HISTORIC LANDMARK COMMISSION
STAFF REPORT

Good Rear Porch Enclosure and Remodel
PLNHLC2015-00010
567 East 900 South
March 5, 2015

A request by Pamela Wells, representing the property owner, Brian Good, to enclose a rear porch, brick-in an original side window and replace two existing windows in the side and rear of the house. The home is located at 567 East 900 South in the Central City Historic District.

North Elevation

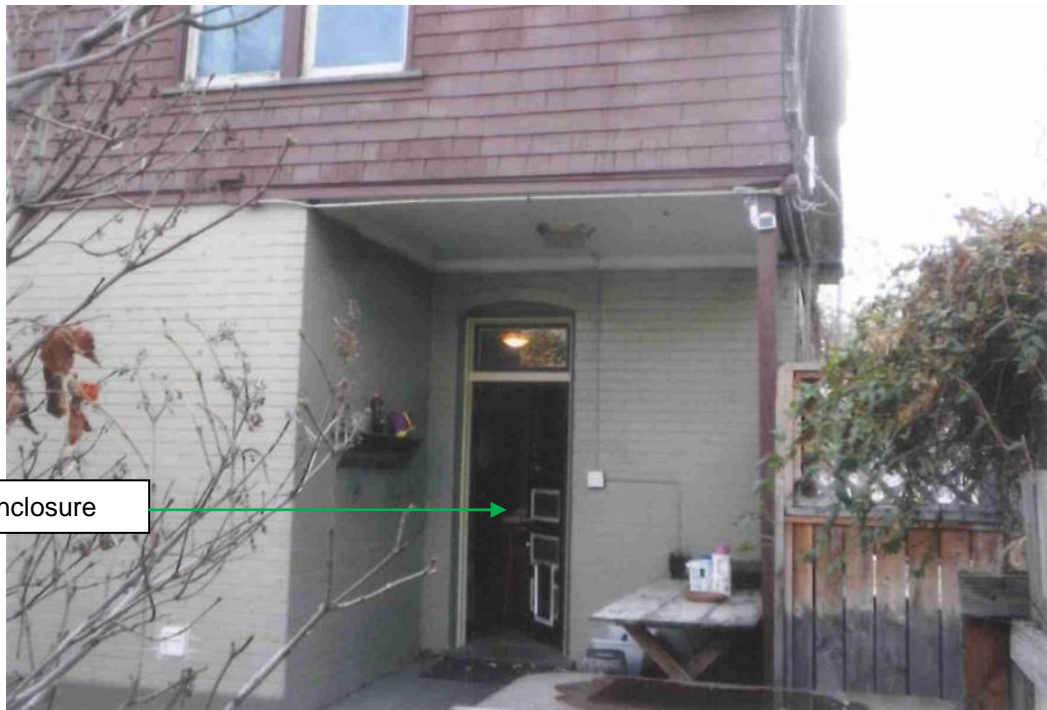
The enclosure will modify the existing rear building façade. However, the proposed enclosure does not change the size and scale of the main building. If said enclosure were built and subsequently removed, the original structure would be unimpaired. The materials proposed for the new addition are compatible with the historic materials of the primary building. The style of the windows and doors are appropriate. The proposal is also to brick-in a window on the west elevation. The location of the window is towards the rear of the building. This window is a defining element of this home.

Finding: The enclosure will be visually subordinate to the principal structure. The proposed enclosure complies with the above design guidelines and therefore the historic character of the property will largely be retained and preserved. However, the proposal to brick-in the window on the west elevation does not comply with the design guidelines 8.1 and 3.2. This standard is only partially met.

West Elevation

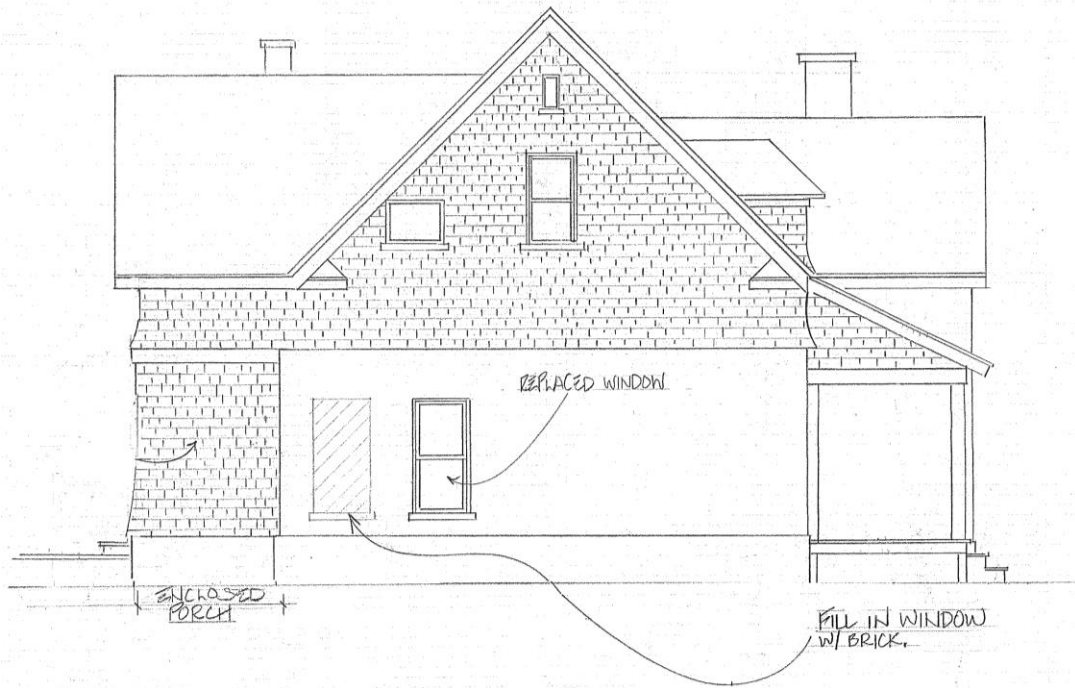
Analysis: According to the applicant the amount of windows and doors in the kitchen limits the space where cabinets can be placed. The applicant is proposing to brick-in a window on the west elevation of the home. The applicant is proposing to keep the expression of the window by resetting the bricks inward. The applicant would like to install a stove with cabinets on top at the location where the window exists. The windows on the west elevation of the home are considered distinctive features.

Finding: Removing one of the windows does not comply with the design guidelines 8.1 and 3.2 which makes it so that this standard is not met. This standard does not apply to the changes proposed for the windows.

BRICKED-IN
WEST KITCHEN WINDOW
SCALE: 1" = 1'-0"

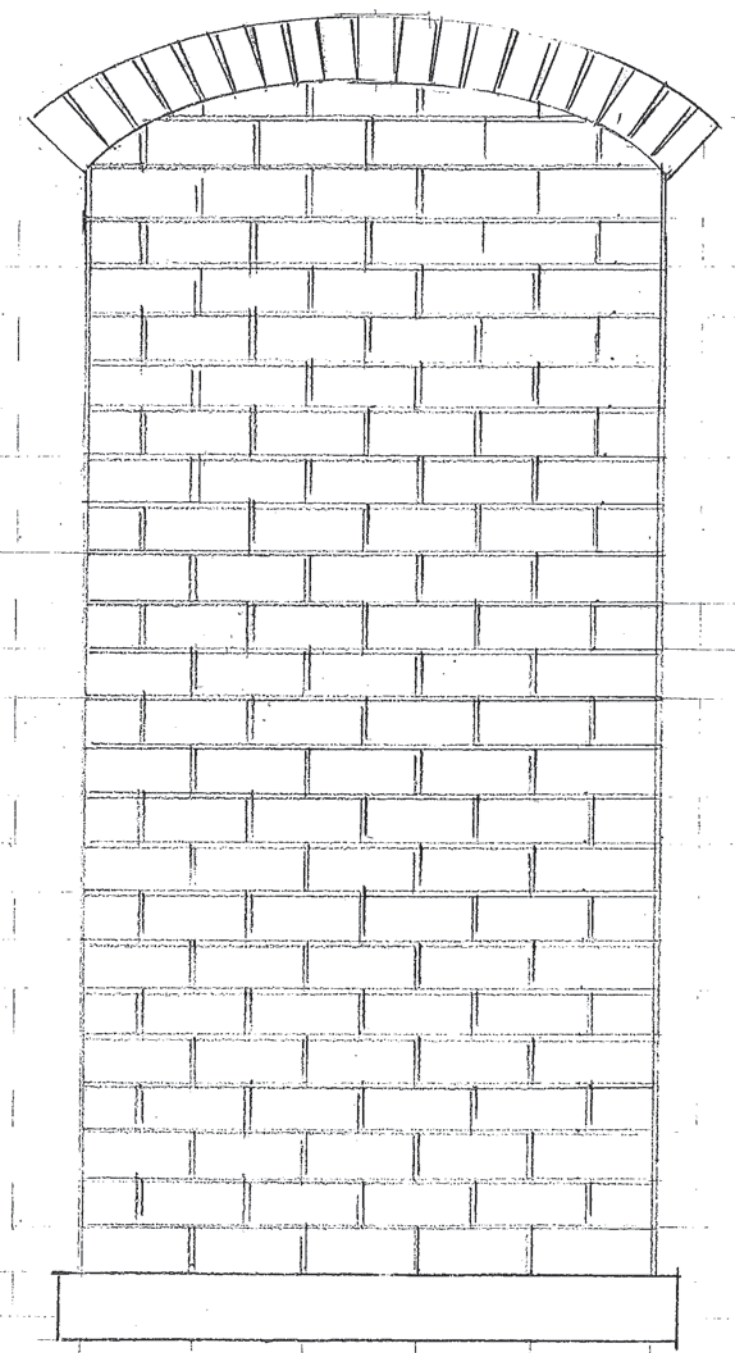
Analysis: If said enclosure were built and subsequently removed, the original structure would be unimpaired. Replacing windows will alter the structure; however, it will not change the form of the structure. However, bricking-in a window will change the integrity of the structure.

Finding: The proposed enclosure and replacing of windows preserves the integrity of the house, but bricking-in the window does not. This standard is partially met.
